From: Mark Everett [meverett@lanl.gov]
To: Young, John, NMENV; John Young
Cc:
Subject: LAOI-7 Proposed construction

LAOI-7 [Los Alamos Canyon, Intermed. the Grandwater]

PRELIMINARY well design

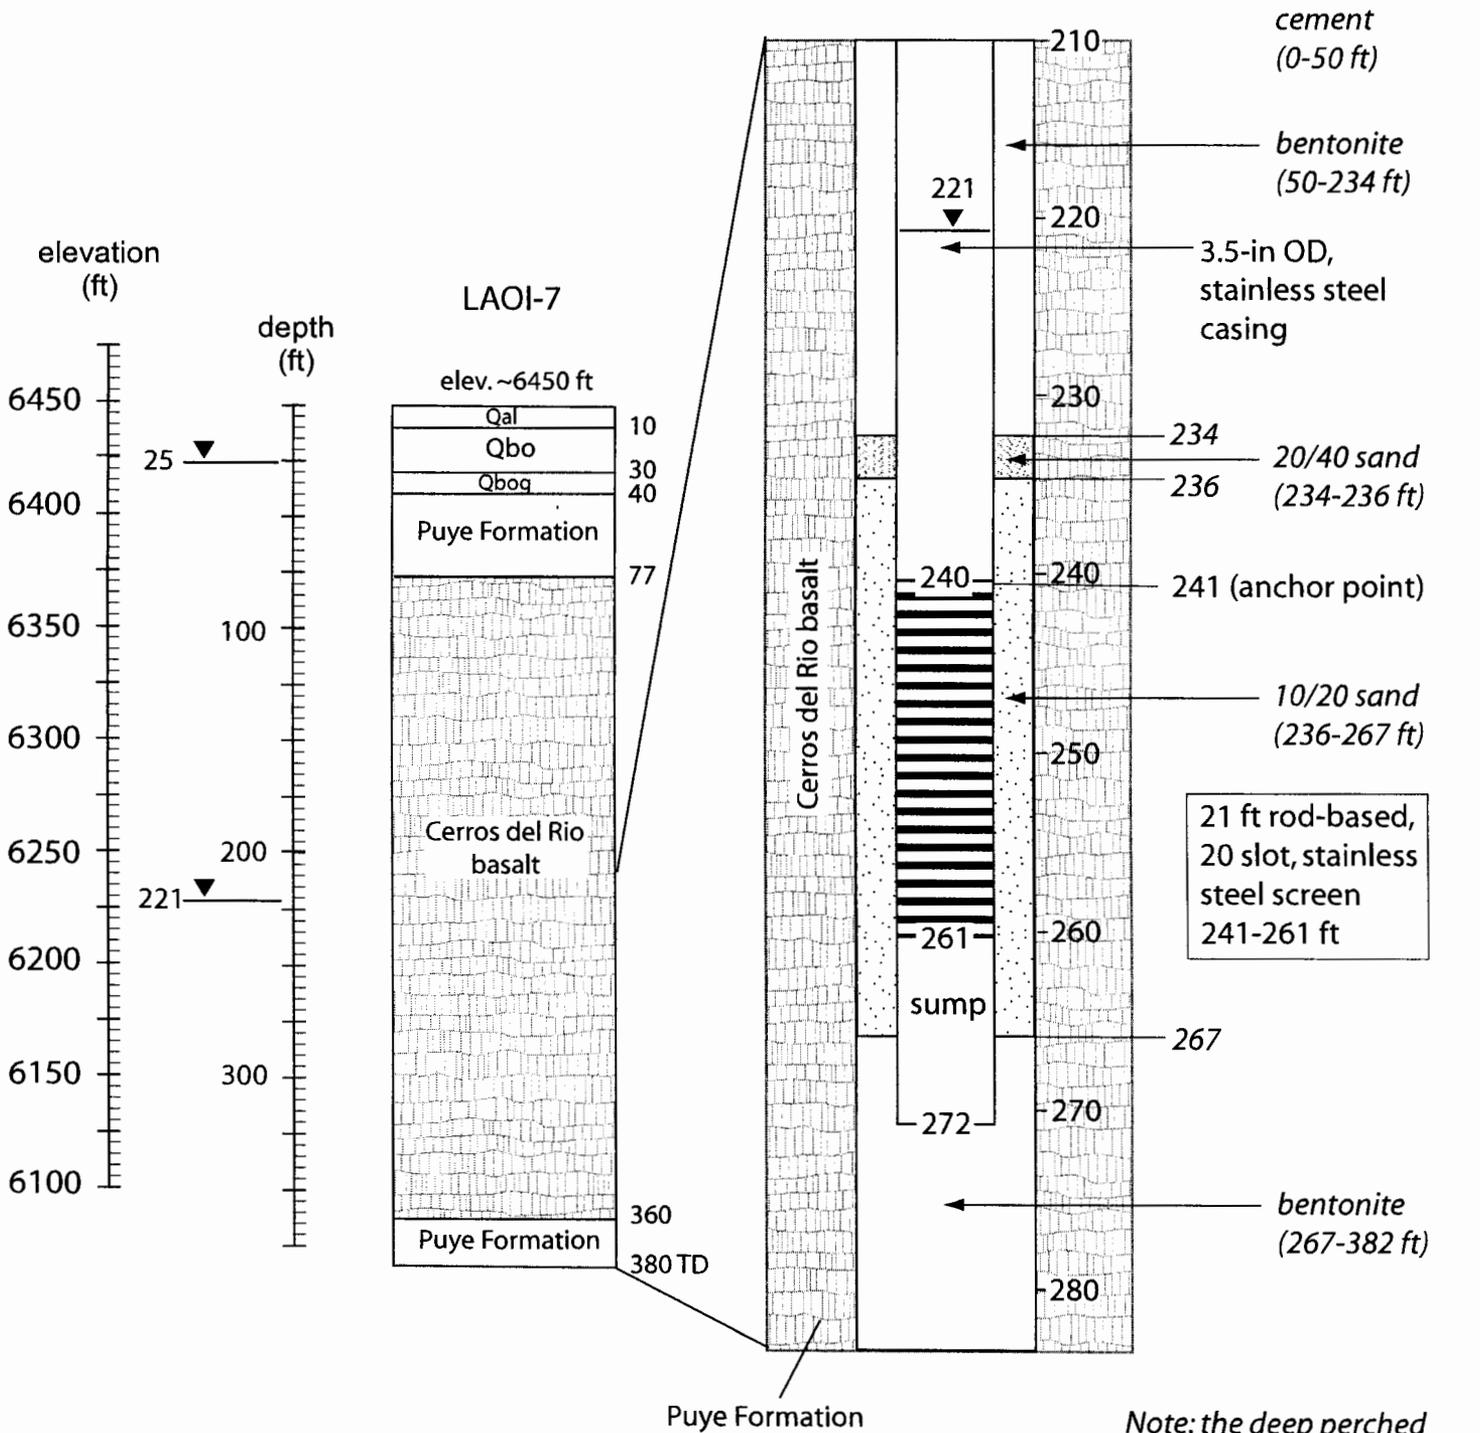
Note: the deep perched zone is confined; first encountered in 237-242 ft core run

OK'd 8/9/05 by phone to Dave Braxton

LAOI-7 (9/8/05)

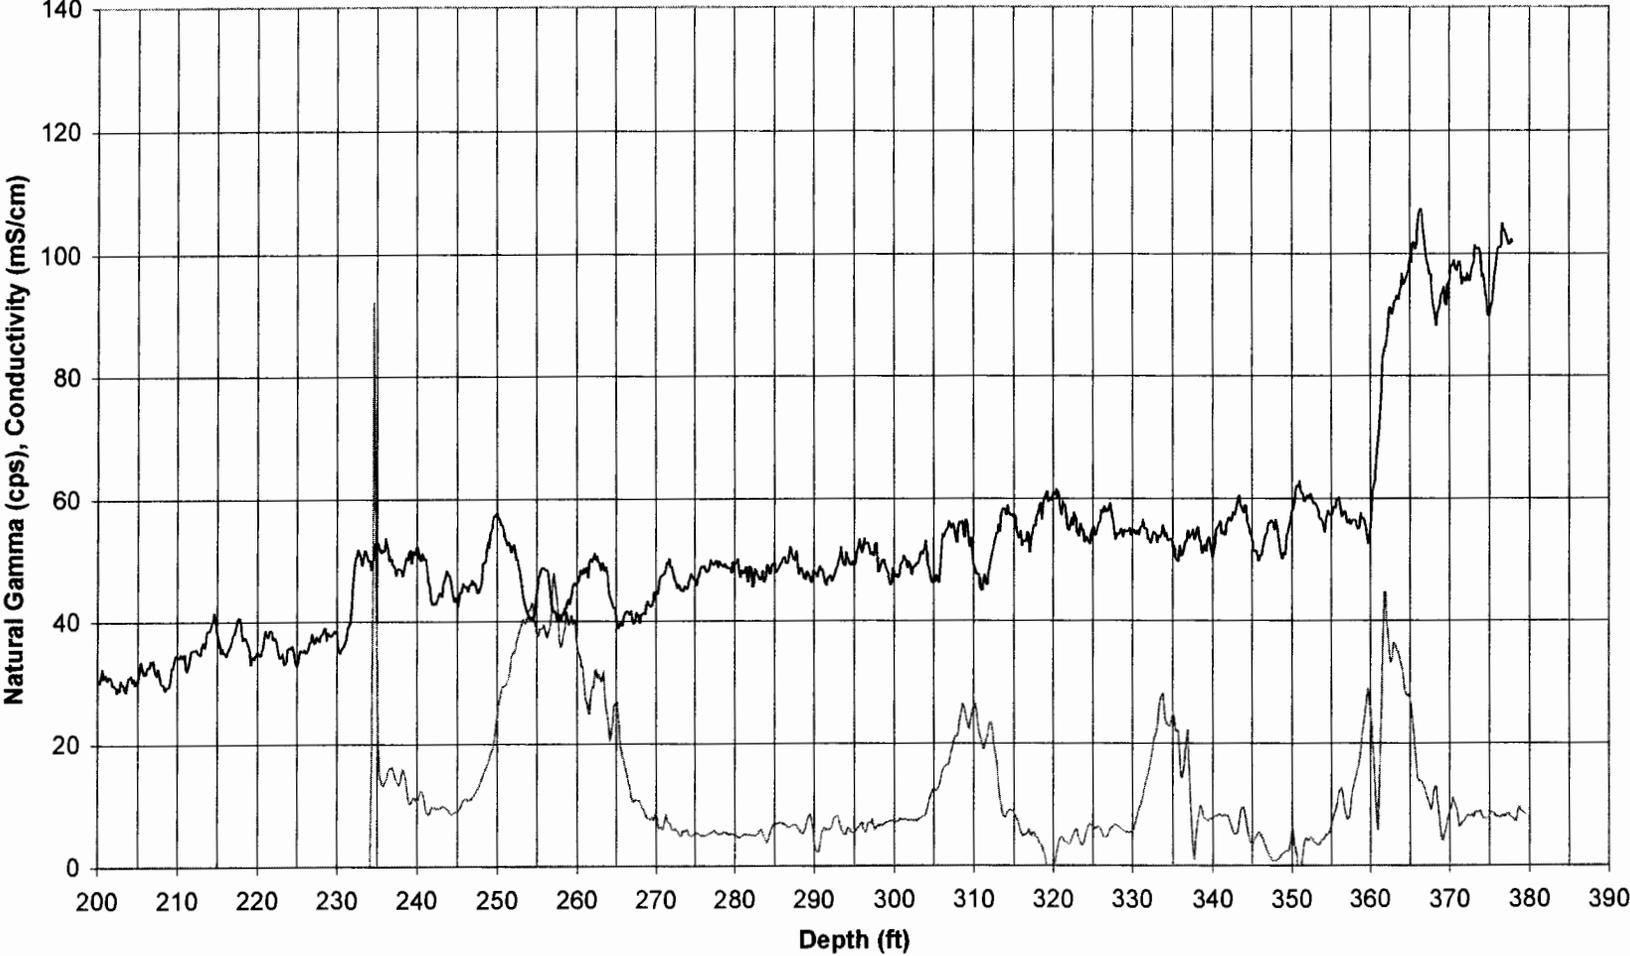
Attached are the borehole geophysics from LAOI-7 and the proposed design. Notes: water appears to be confined - first encountered in 237-242' core run and rose to 221', borehole video logs indicate well brecciated zone at 249-262', bottom of 6" casing at 232' and base of basalt is at 360'. Our proposed well screen covers the first observed water and the breccia zone (see attached geophysics). Please contact me so that we may discuss.
